Authority for Nuclear Safety and
Radiation Protection

2nd Netherlands' *National Action Plan* (NACp)

Borssele Nuclear Power Plant

Figure 13 – Combination of the direct injection to the vessel wall and the passive draining of the sump water to the vessel wall

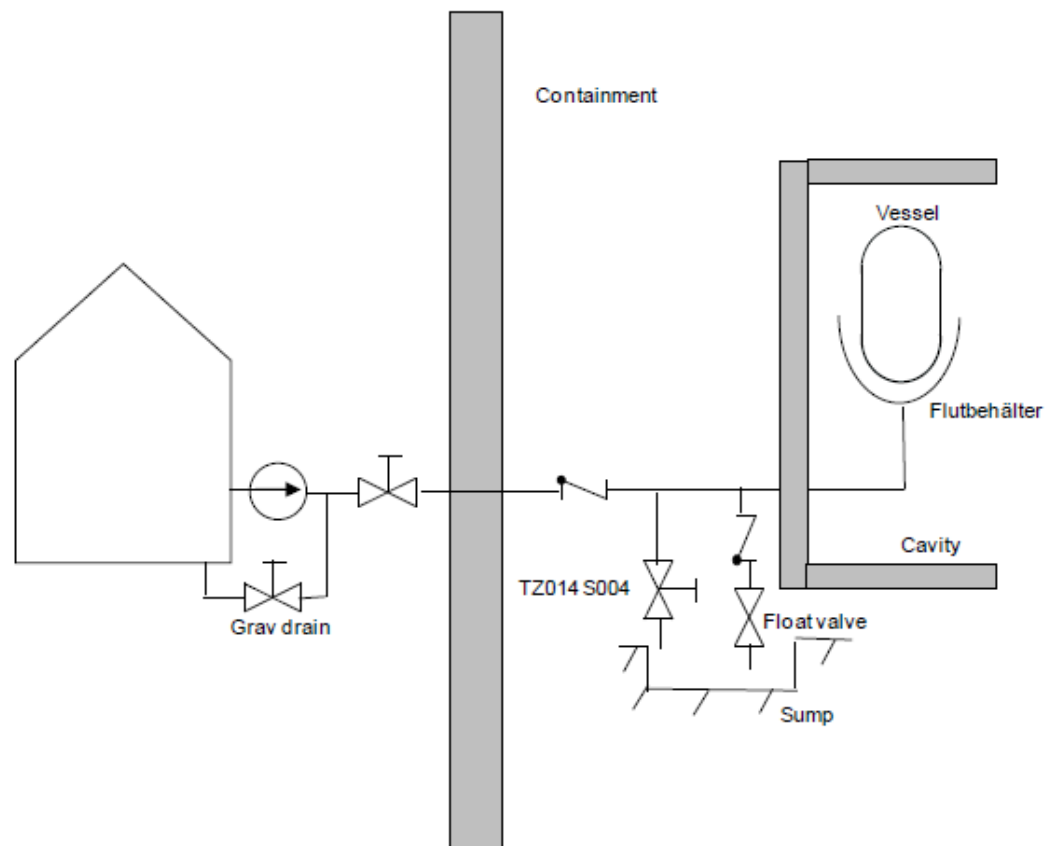
46	Austria (RAP)	Netherlands	3	95	<p>For NLA No. 4, it is noted that post core melt dose rates were evaluated and dose rates at the refuelling floor in relation to the SFP level were calculated. However, the outcomes of these evaluations and calculations are not reported.</p>	<p>The outcome is as expected that during a core melt and under a certain level in the SFP dose rates become too high in certain areas of the plant.</p>
47	Austria (RAP)	Netherlands	2	107	<p>For NLA No. 38, it is noted that the impact of aircraft was studied and documented. However, the outcomes of these studies are not reported.</p>	<p>The outcomes of the aircraft study is classified and therefore not reported.</p>
48	Austria (RAP)	Netherlands	3	44/107	<p>The rapporteur's report 2013 noted the <i>[w]ithin the frame of the ongoing PSR and NAcP also the possibilities for in-vessel retention of molten core are investigated</i>.</p> <p>In Table 3.1, ENSREG item 3.1, it is noted that the analysis of in-vessel retention in the PSR 2013 is completed. Under the same ENSREG item, NLA 39 concerning hydrogen threats is also addressed.</p> <p>However, in table 8.1, the results of the analysis of in-vessel retention are not reported; this work is not mentioned at all in table 8.1. (Whereas information is provided for NLA 39.)</p>	<p>These studies have been performed. For more information, refer to question 19 about in-vessel retention.</p>
